ONE 90 (PREVIOUSLY WATERS TECHNOLOGY PARK )  
PA 18-013 MODIFICATION SUBMITTAL :  
ISSUE DATE: 10-13-20

PA MODIFICATION - INTENT AND DESCRIPTION:  
To review and approve architectural building related design modifications made during plan check for code compliance and constructibility.

PA MODIFICATION COBALT- BLOCKS REVISIONS SUMMARY

PA MODIFICATION - INDIGO ROWS REVISIONS SUMMARY

ROOF LEVEL PLAN

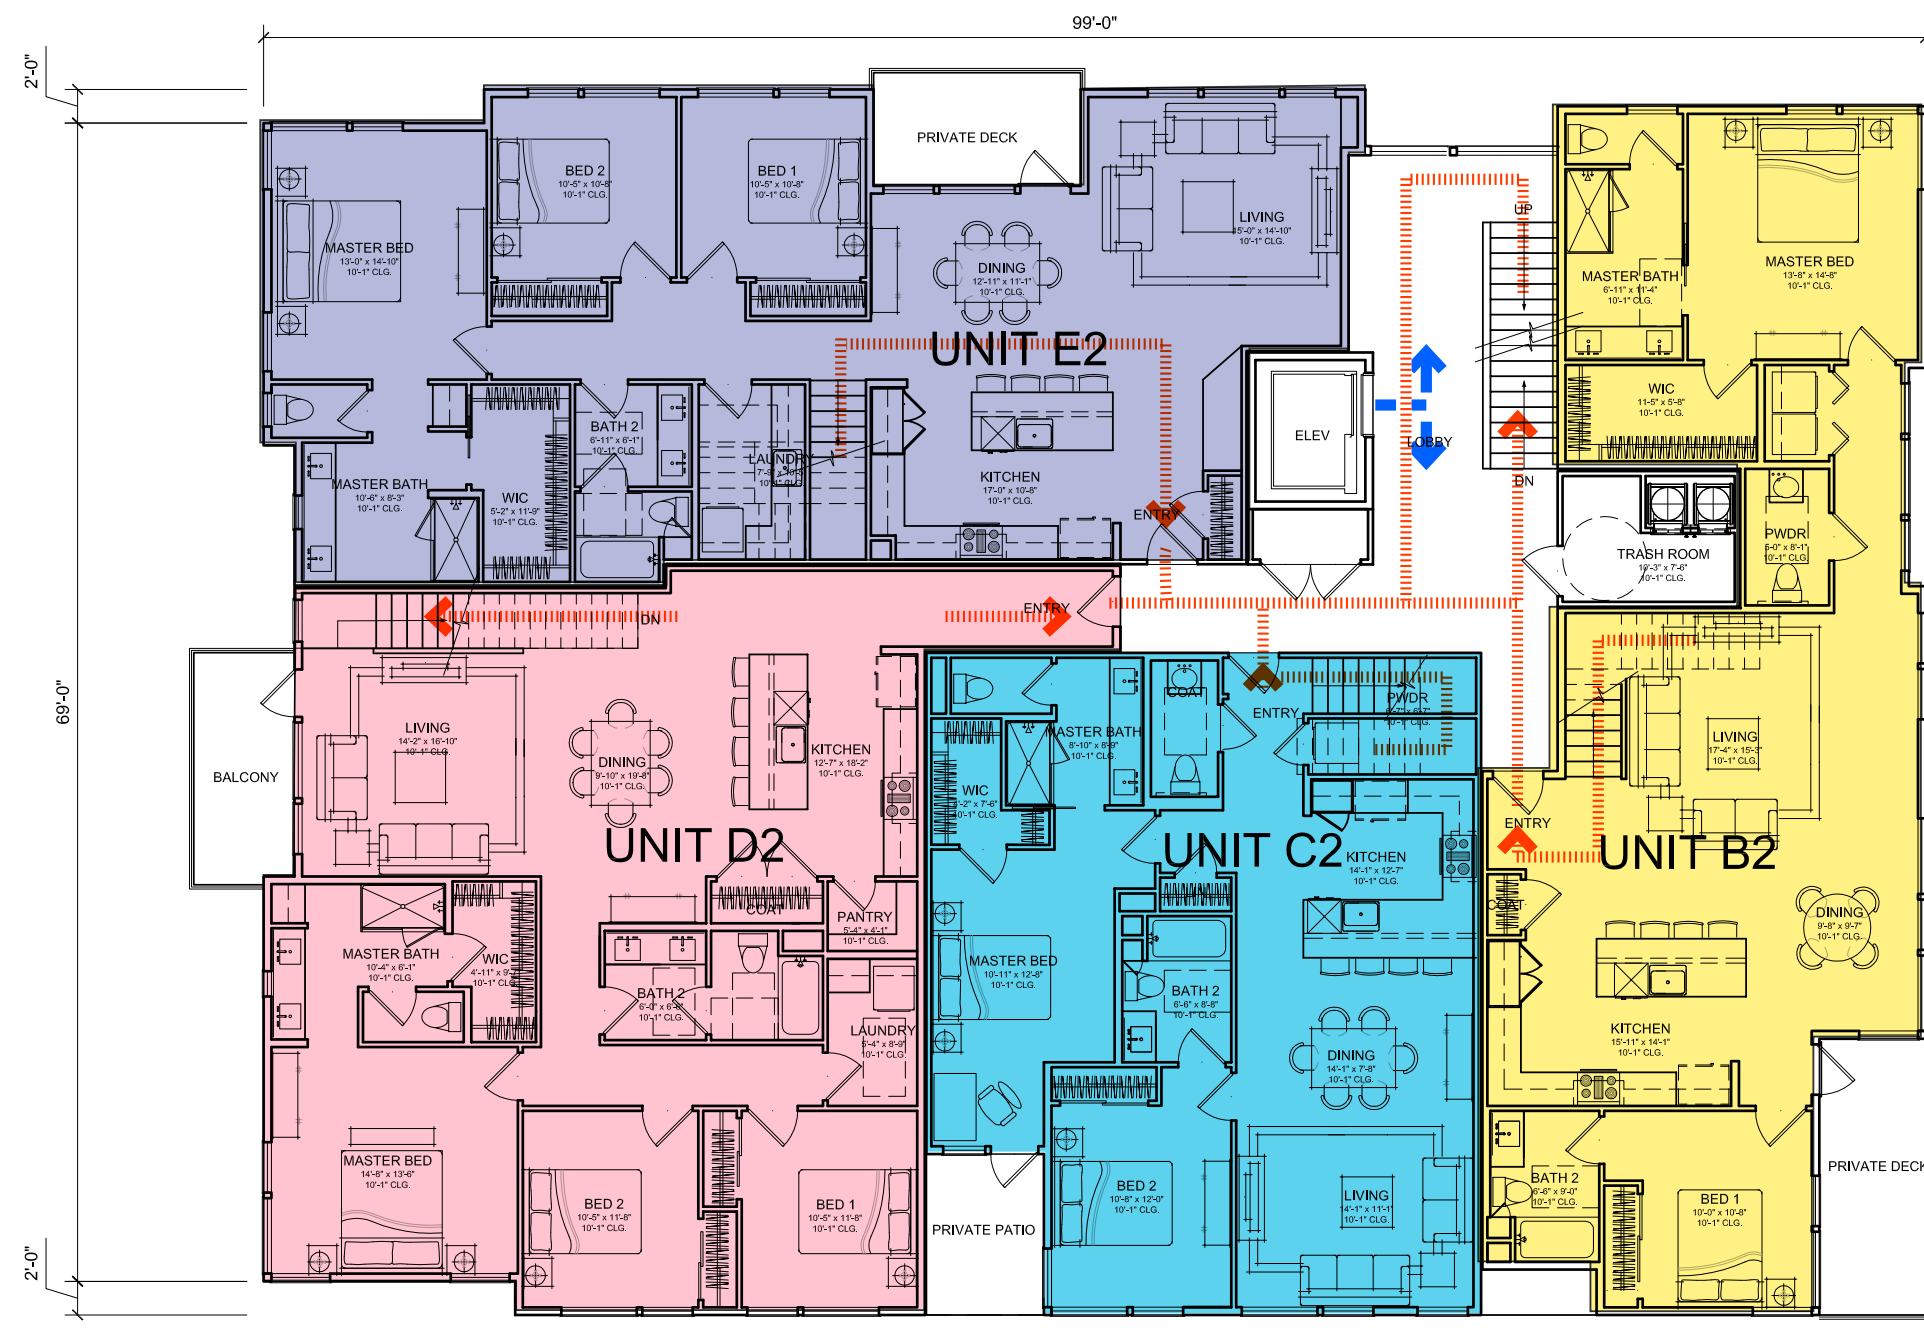
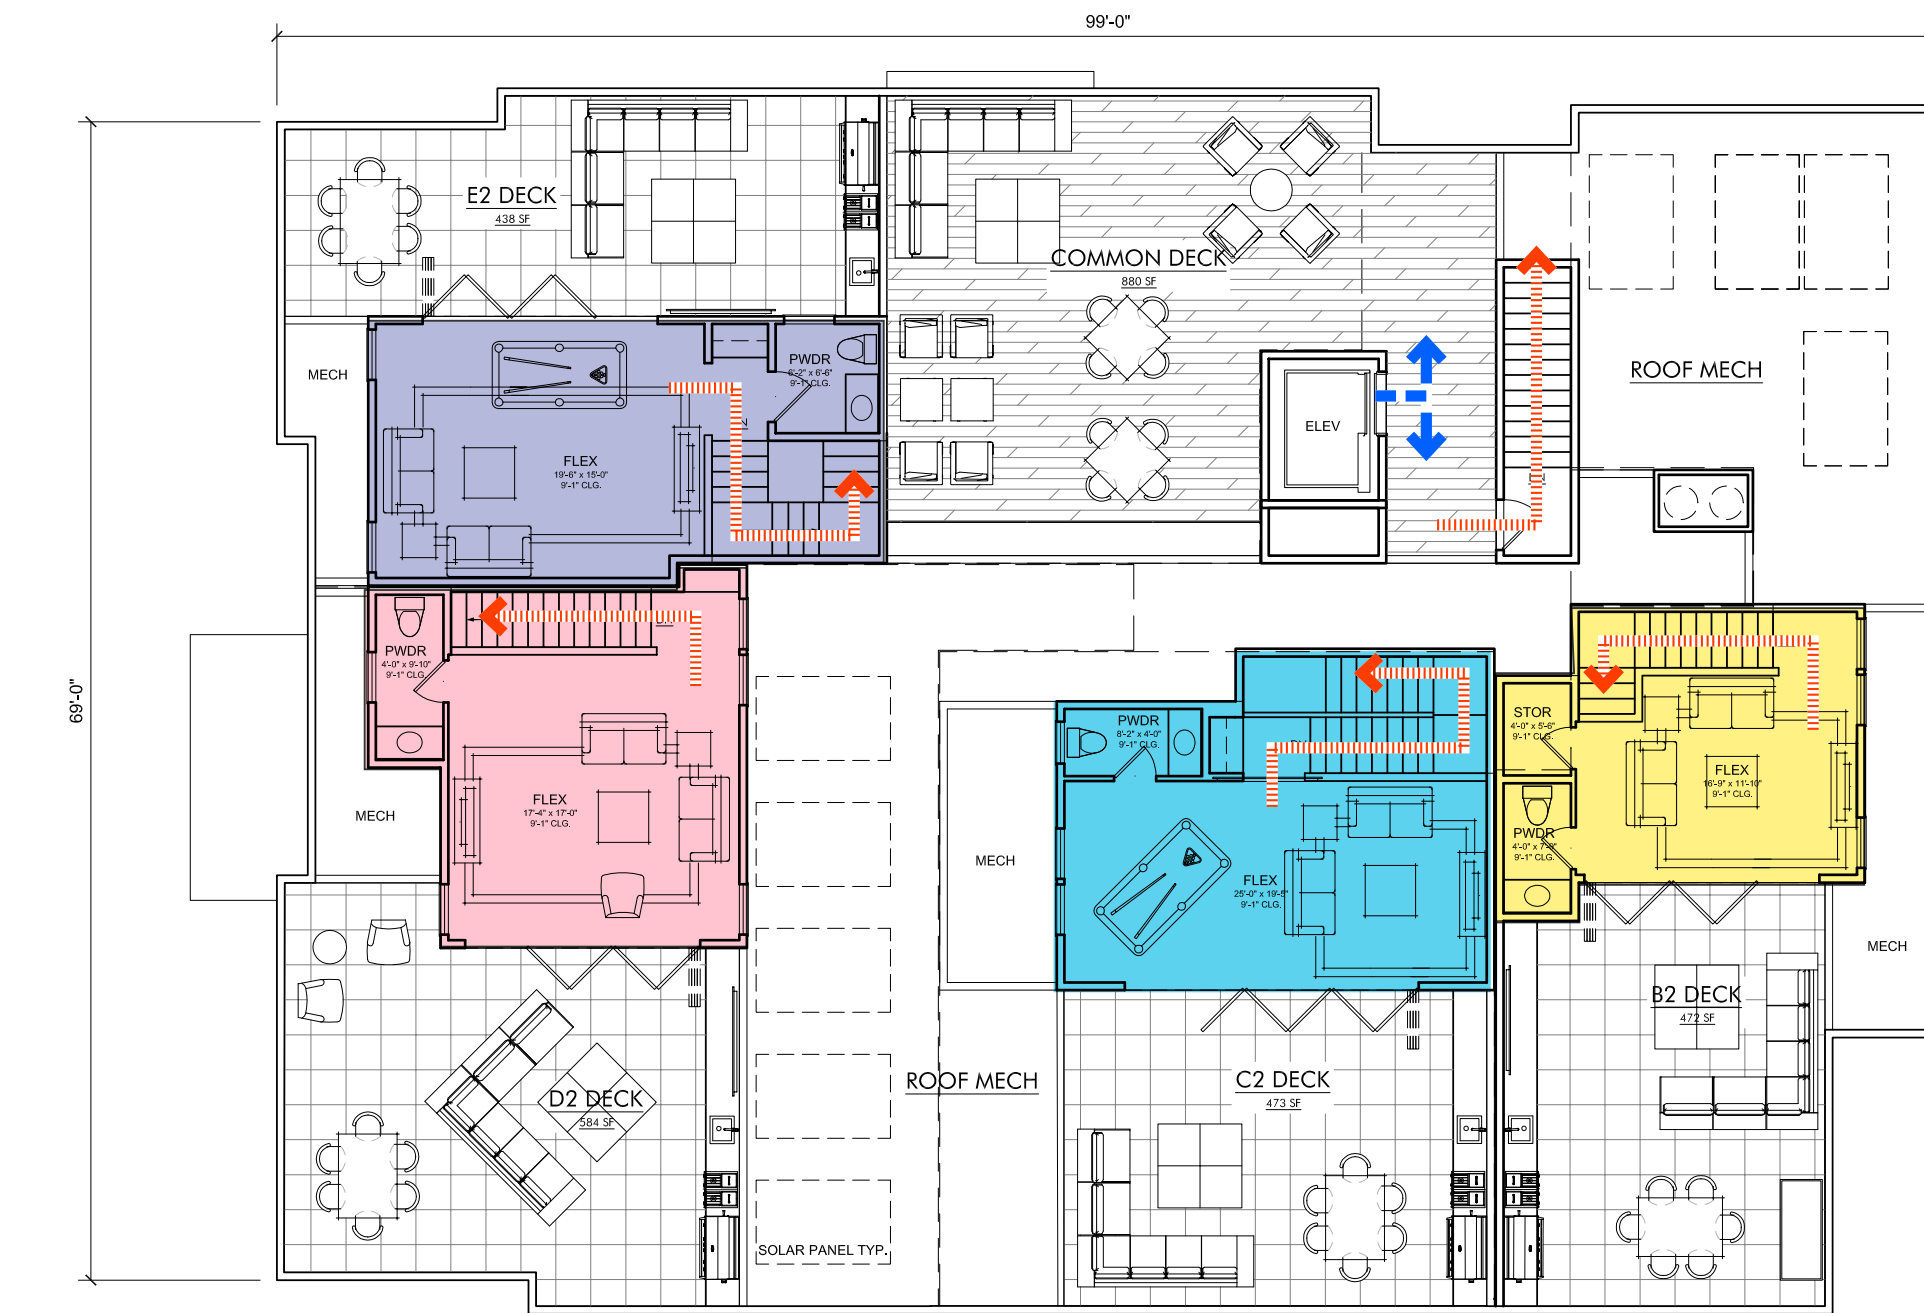
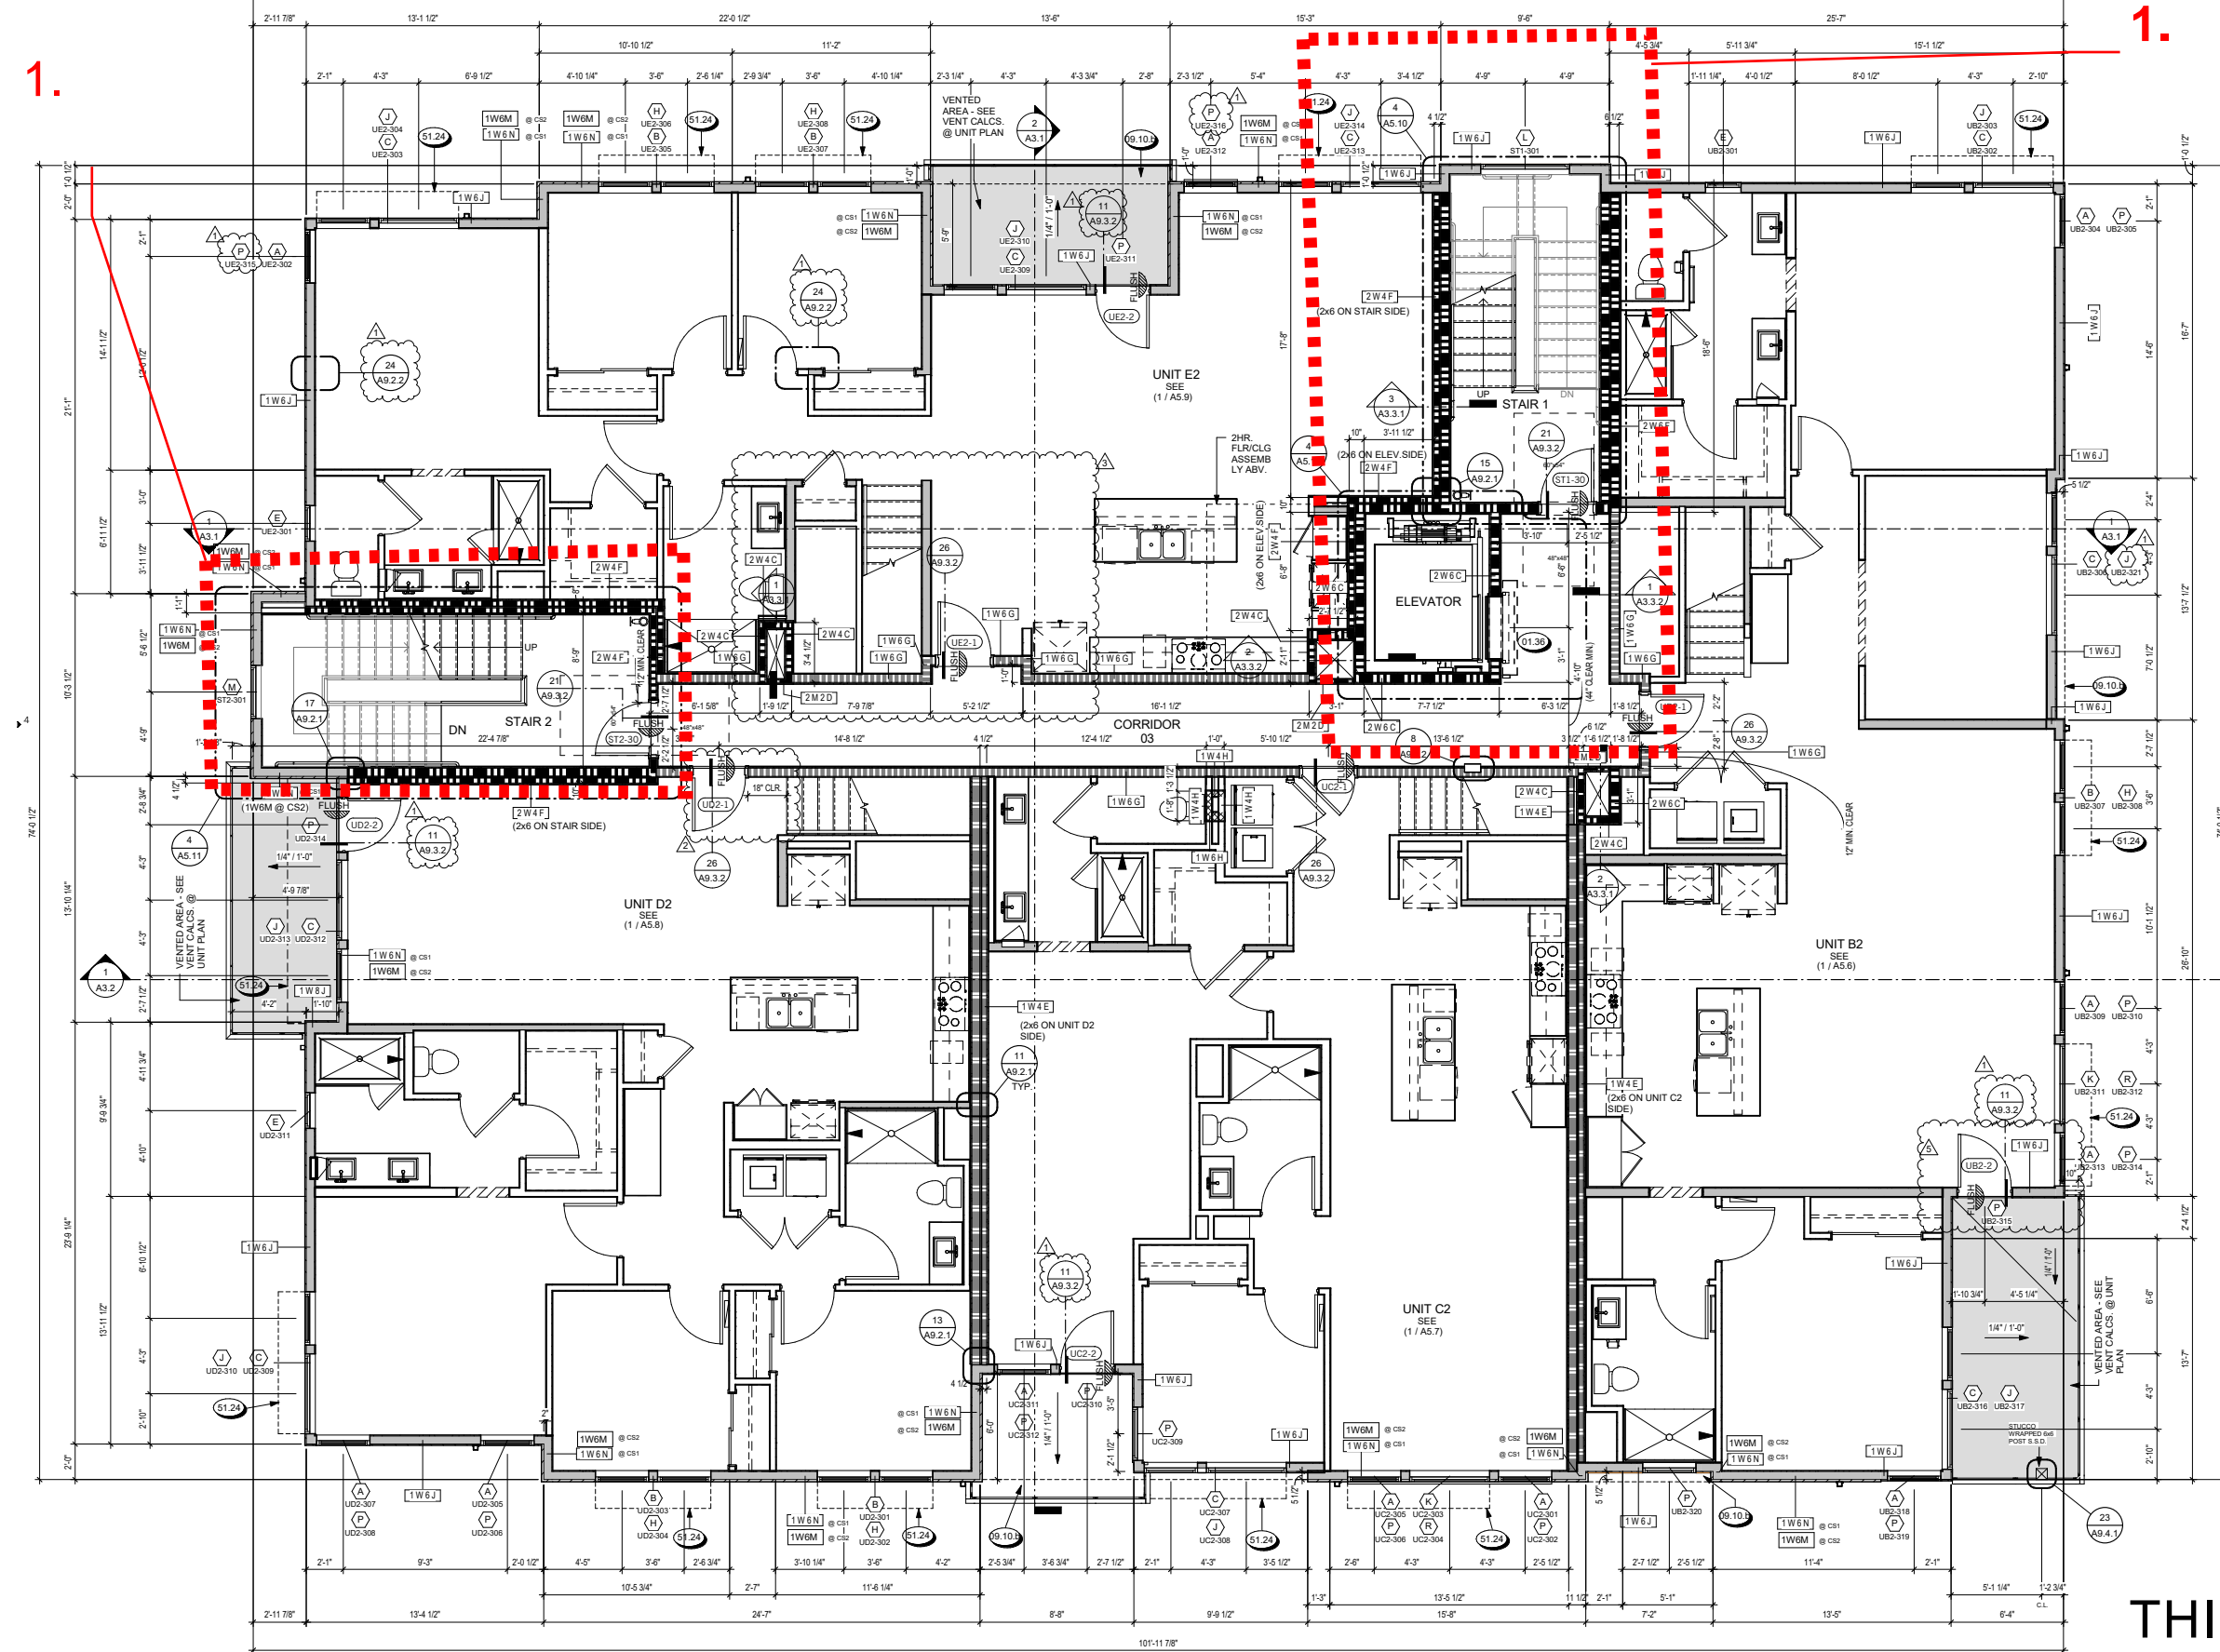
Providing alternative to PV system, installing 8'x 5' solar hot water systems on roof.

1. Reconfigured common hallway and exit stair to meet code compliance on all floors.
2. Extending both stairs to roof deck and added elevator mechanical room.
3. Reconfigured private roof deck by relocating the guard rails to the exterior corner for structural constructability
4. Extended living area for unit B2 to accommodate interior stairs. Created an accessible elevator vestibule
